Planning Commission

Wednesday, May 3, 2023

**TECHNICAL REVIEW PLAT REQUIREMENTS
REGULAR PLANNING COMMISSION MEETING
MAY 3, 2023**

Preliminary Plat
WHITECAP
NORTH PADRE ISLAND

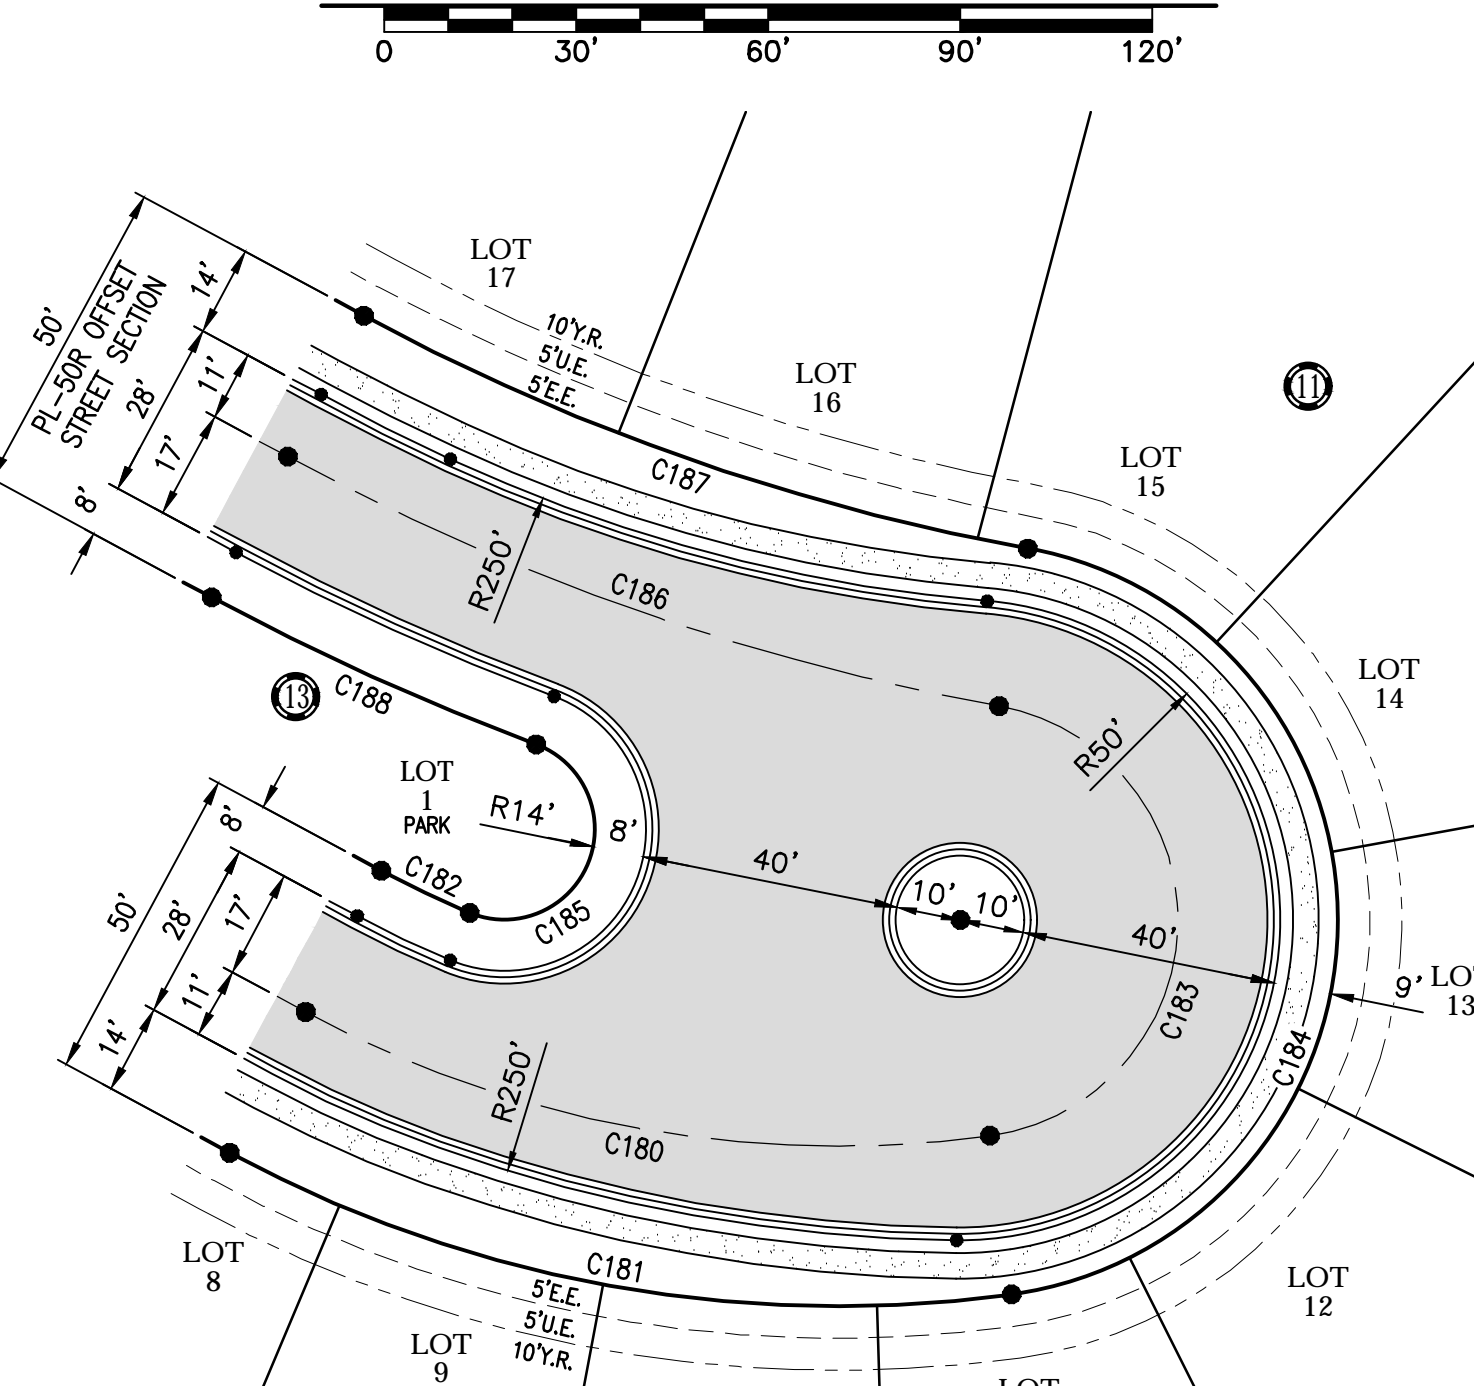
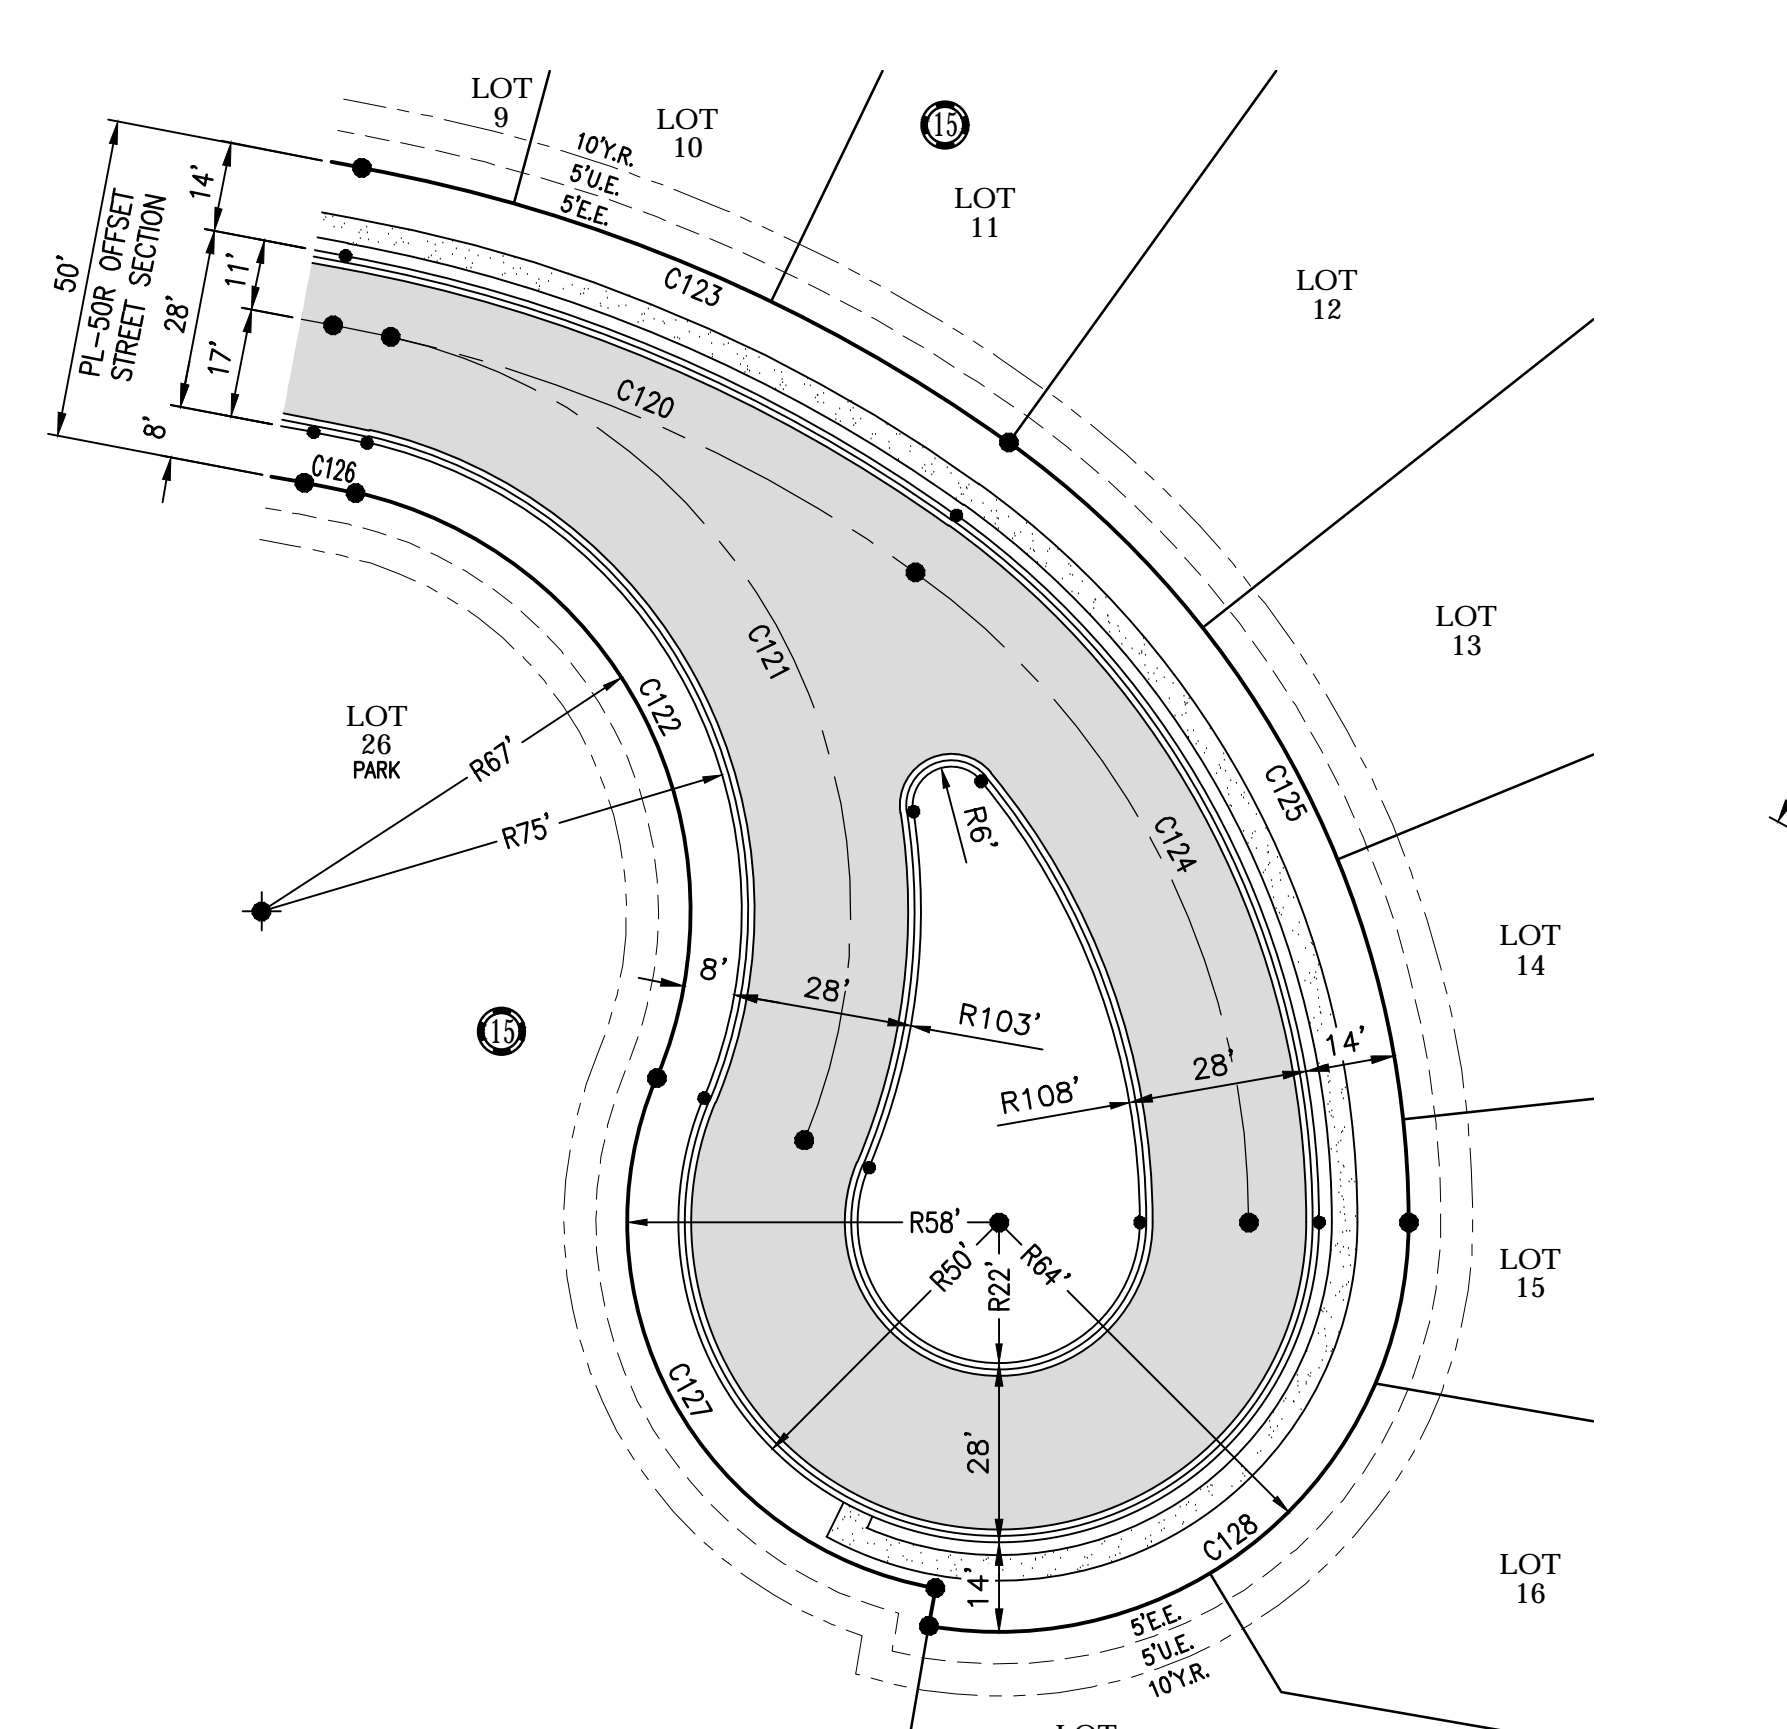
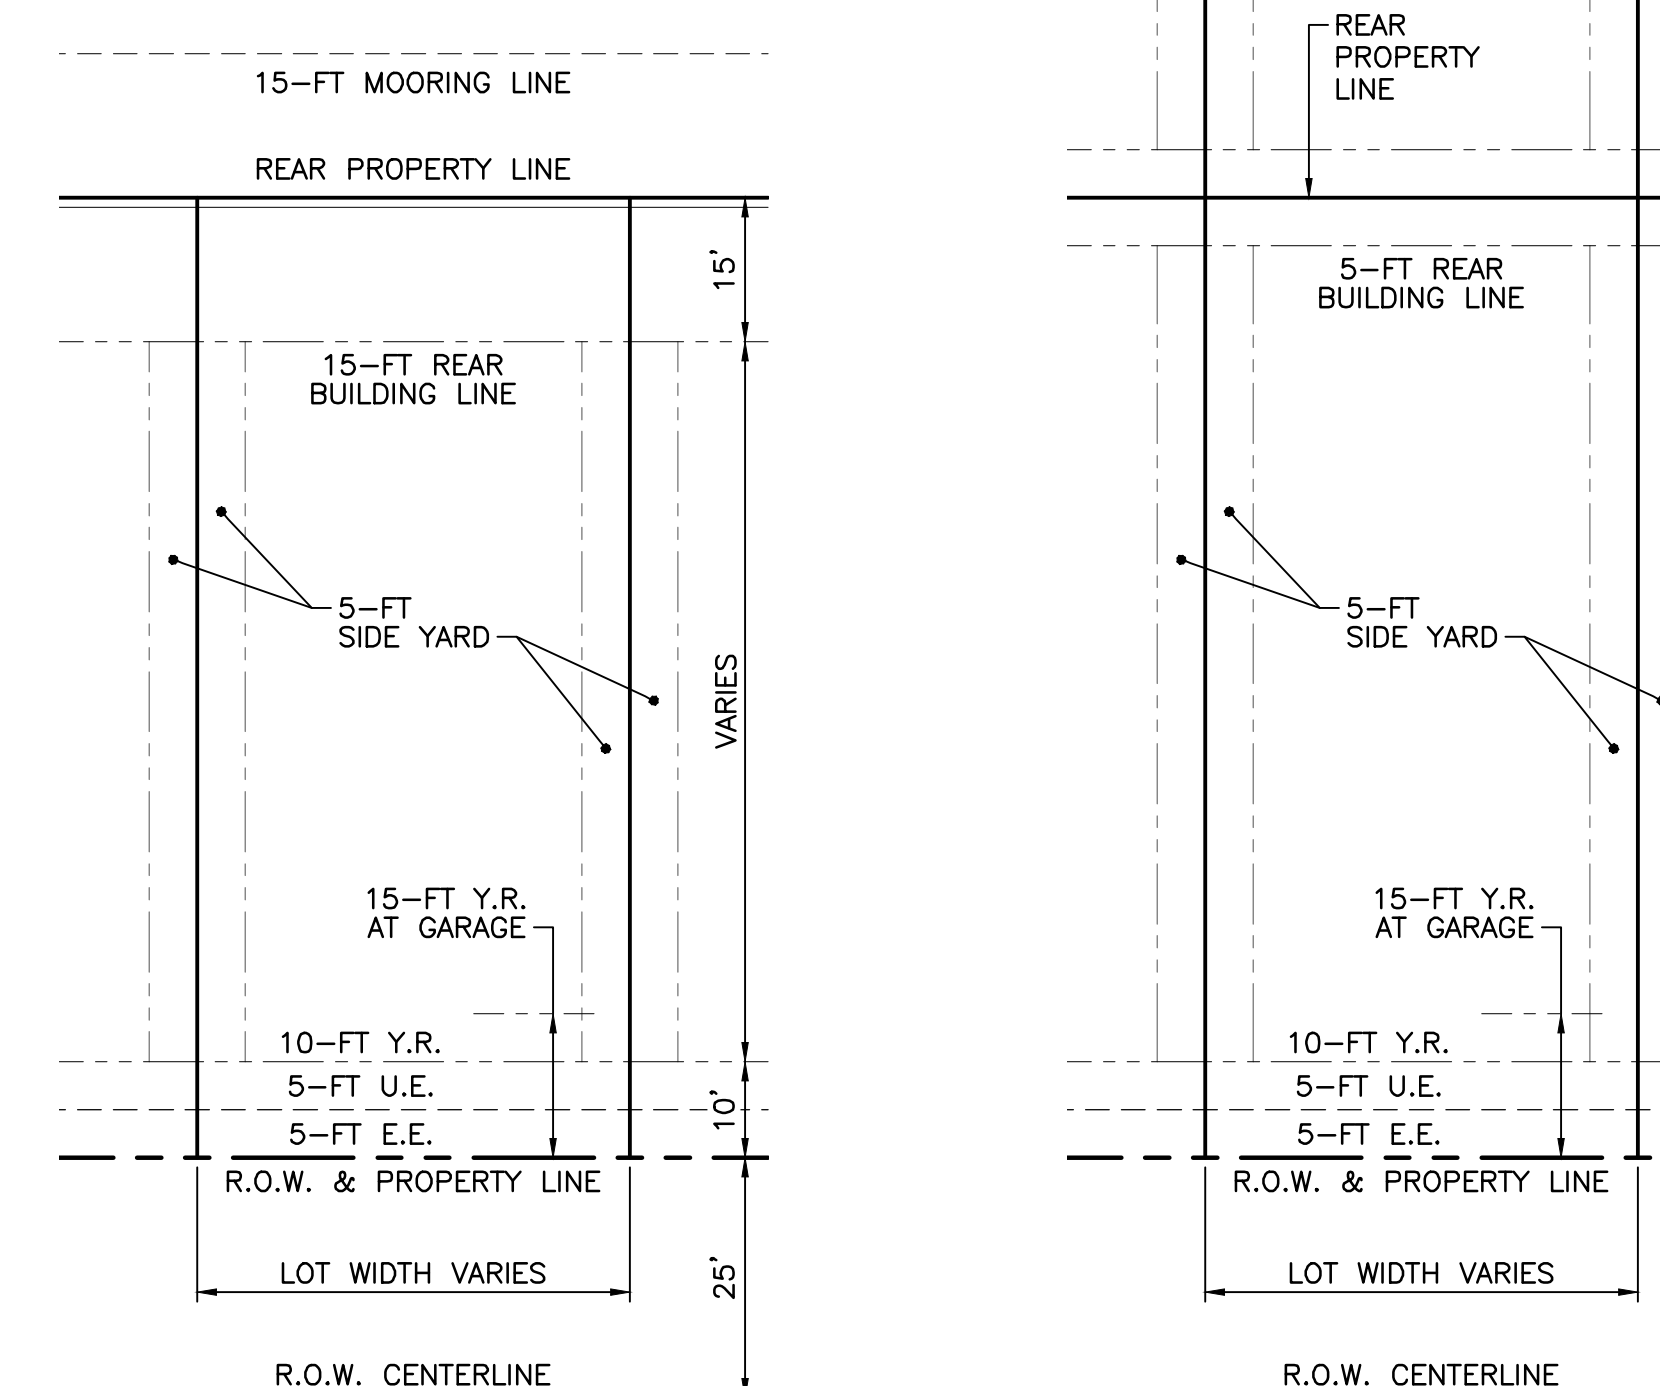
6	Plat 2	Provide Bold type labels for each phase Unit within each Unit boundary for each sheet.	Complete.	Addressed		
6	Plat 2	Provide Flood plain boundaries with labels on plat or verify Plat note 2 indicating entire property is in AE zone. Provide contours in light weight lines on plat.	Complete, noting that the addition of contours necessitated the addition of the existing bulkheads. Additionally, note that the plat displays the contours following the Site Work improvements that are currently nearing completion, while the SWQMP displays the pre-existing contours.	Not addressed. New construction contours to be on Public Improvement plans (Remove from plat). Existing contours requested are by the Prelim plat application checklist. Remove floodplain boundaries from Sheet 1 Phasing Plan. See previous submitted Sheet 1. Do not change as submitted.		
6	Plat 2	Provide legal description, ownership and recording information for adjacent south and north adjacent	Complete.	Addressed

7	Plat 2	Provide "Private Park" label for Block 5, Lot 2 & 3. Provide "Private" to all Park lots on all sheets.	"Park" label added. General Notes on Sheet 1 designate all parks as private.	Not Addressed. Label as "Private Park" on plat.		
8	Plat 2	Provide lot and block number for Navigable Channel. Area to be included in Final plat and recorded as a Lot. Square footage should be provided. Include Navigable channel to note 8 and additional requested on LD comment #5.	This plat is notated and numbered in accordance with the precedent set by the existing island subdivisions (e.g., see Coquina Bay, Barataria Bay, Point Tesoro, Ports O' Call, etc.). Square footages of Navigable Channels have been added within the plan. Note that assigning lot numbers would 'tie' blocks together across the channels, for example, converting the channel between Units 1A and 1E to a lot would combine Blocks 1, 2, 12, & 14 into a single block. And to the extreme, numbering the channel east of Phase 1B would combine Blocks 7, 11, 15, 16, 17, & 46 into a single block spanning Phases 1B, 1C, 1D, and 1E.	Addressed; further maintenance obligation to be on Developer Agreement.

9	Plat 2	Adjacent easements to shown and labeled for adjacent properties. (10' UE along Aquarius St. and on north border).	Complete.	Addressed		
	Plat 2	Previous plat references 7.5' UE crossing Unit 1A and 1E. Indicate whether it is closed. If not, then Easement closing by separate document will be required prior to Final plat recording.	Acknowledged.	Addressed		
10	Plat 2	Proposed bio swales to be in Private Drainage Easements labeled on the plat.	Complete. See Land Development Comment 3 above.	No Addressed. Label as "Private DE" on plat.

11	Plat 2	Lift stations and WW lines to be in easements, whether in Private UE or public UE.	Utility Easements have been added to all lines and will Lift Station easements will be added during the Final Platting/Construction Drawings phase of work to fully encompass the limits of the Lift Station infrastructure.	To be Addressed with Final Plat		
12	Plat 2	Utility lines outside plat boundary to be in an Easement recorded separately and labeled with document number on Final plat. Show easement for force main outside boundary.	Acknowledged, including addition of Offsite Utility Easements for Wastewater, as applicable.	To be Addressed with Final Plat		
13	Plat 3	Provide legal description, ownership and recording information for all adjacent properties on Commodores Dr. and Compass St.	Complete.	For adjacent properties with a recorded plat, only the Subdivision name and volume/page of Plat is required (one label). For properties not platted, the owners name and document number is required for each property. All easements, lot labels, and setback labels should be shown.
